REQUEST FOR INFORMATION (RFI)

RFI No.: ABF-RFI-003170R00 Submitted By: OSullivan, Bill Pages: 2
 RFI Date: 17-January-2013 Contact Name: Osullivan, Bill Phone No. 510-808-4602
 Pages Attached: 0

Subject: Light Pole Anchor Bolts: Scope of Work	
References:	
Sub/Sup: ABF	Sub RFI #:
Response Required by: 24-January-2013	Response affects critical path activity?

ORDER NUMBER:	129910-P2
PAGE NUMBER:	1 OF 2
DRAWING NUMBER:	129910P2
REV	57

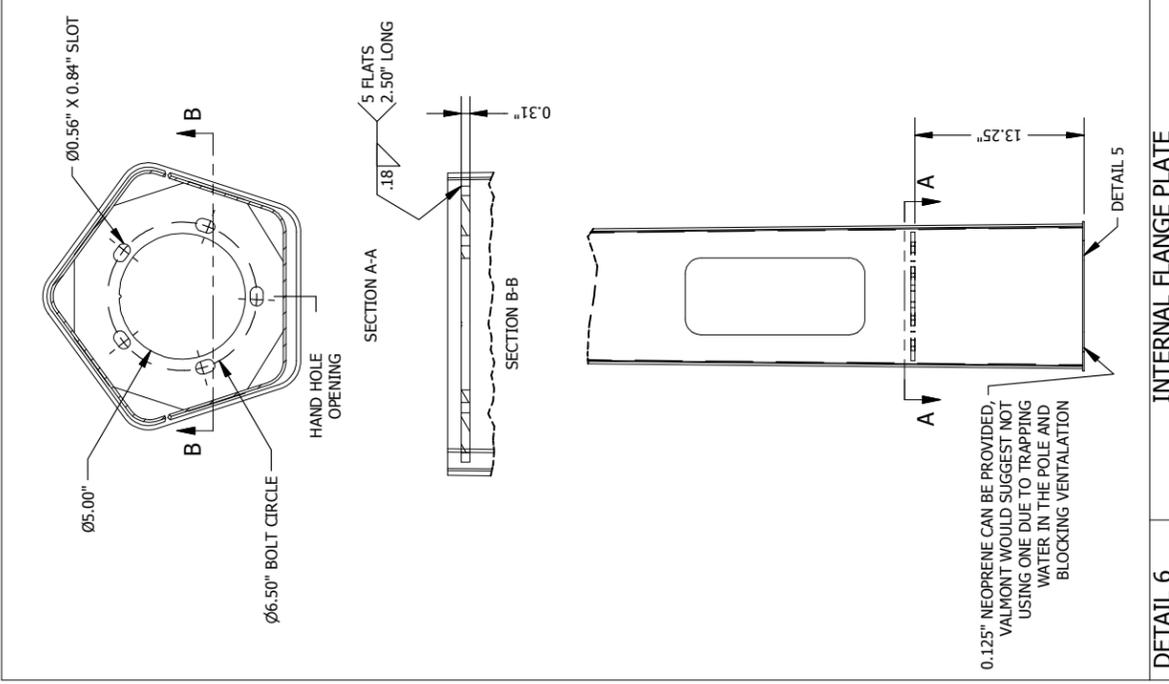
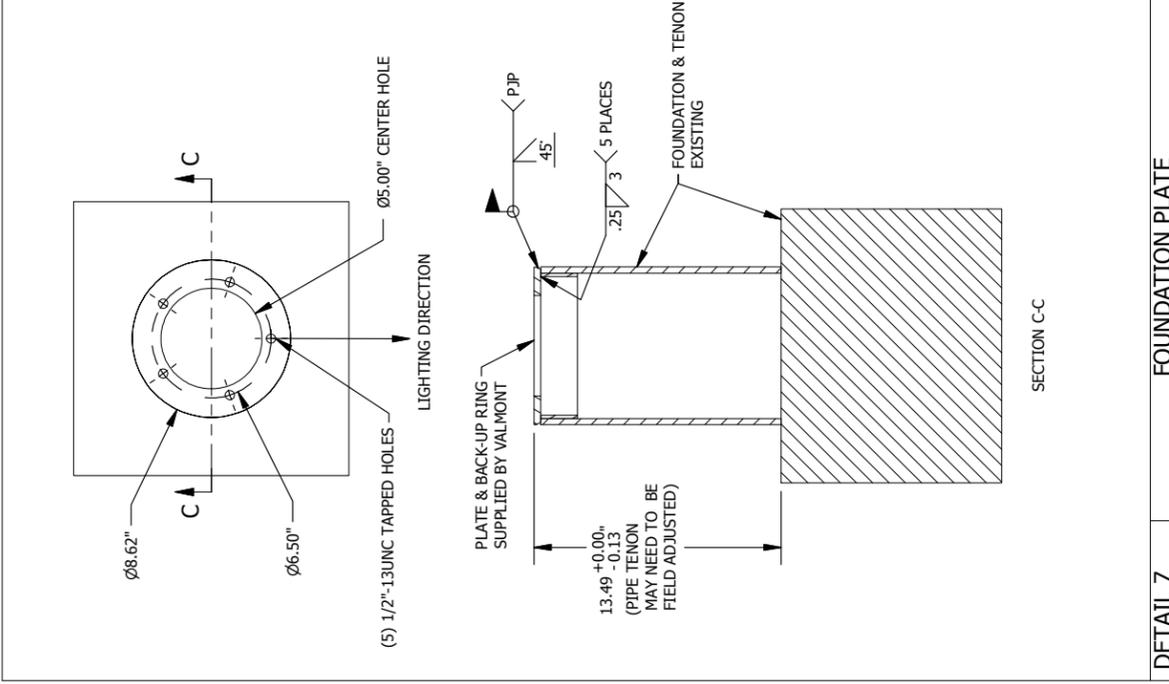
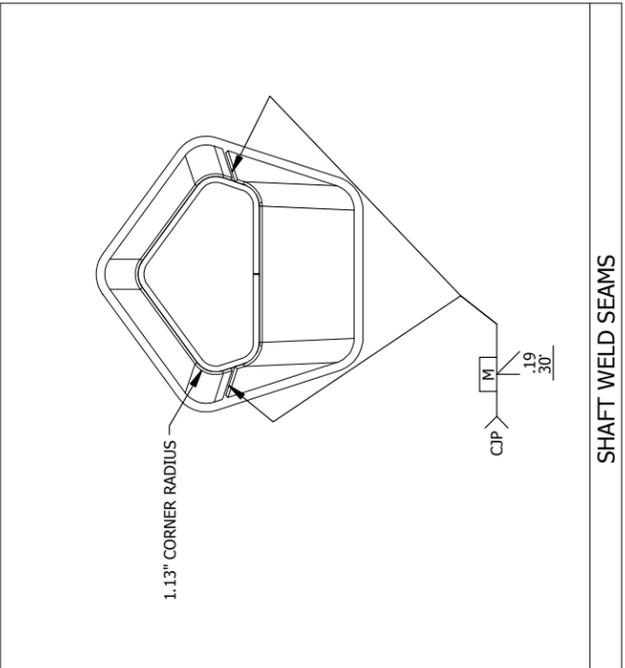
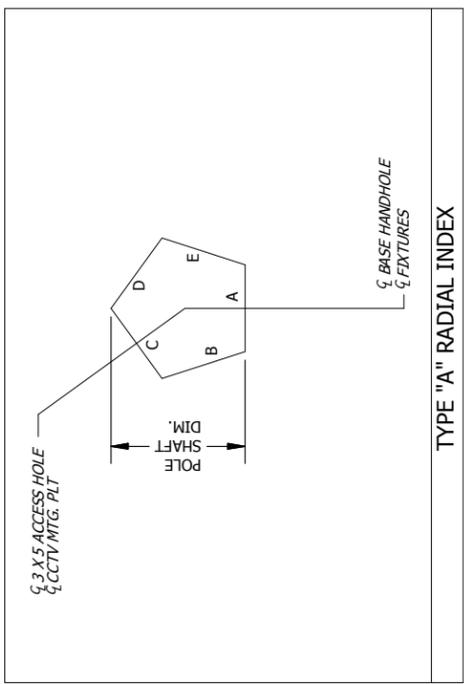
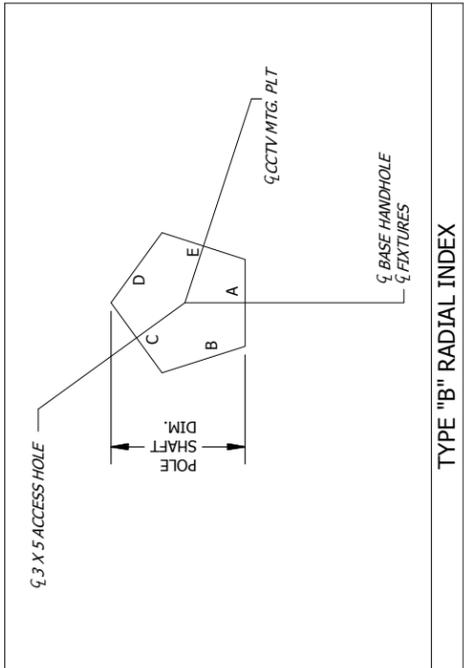
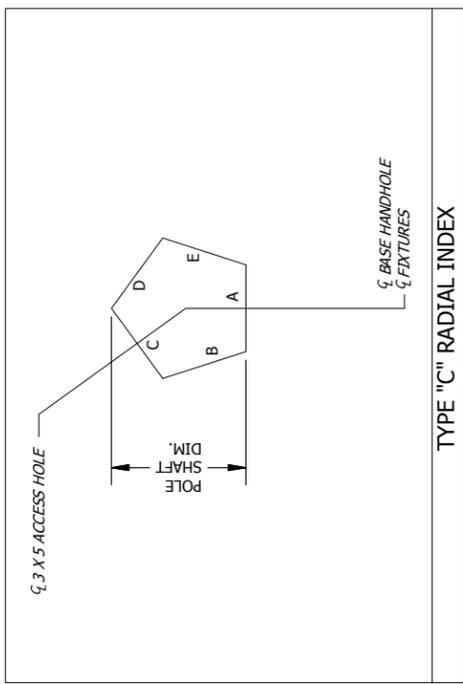
7. Advise if bolt caps shall be installed over the light pole anchor bolts in all locations.
8. Confirm that the Slip Joint Detail to secure the Light Poles to the Belvederes still applies. (Ref Plan Sheet 214R1). Confirm that tamper plates will be provided inside the Belvedere Light poles per Section C-C. Provide clarification which welds shall be performed in the field.

8. The slip joint connection detail shown on contract plan sheet 214R1/1204 no longer applies. The base connection detail was changed to what is now shown on the approved shop drawings from Contract BATA #7 (Valmont drawings 29910P2 – 2 pages). Unmarked, unstamped drawings are attached for reference.
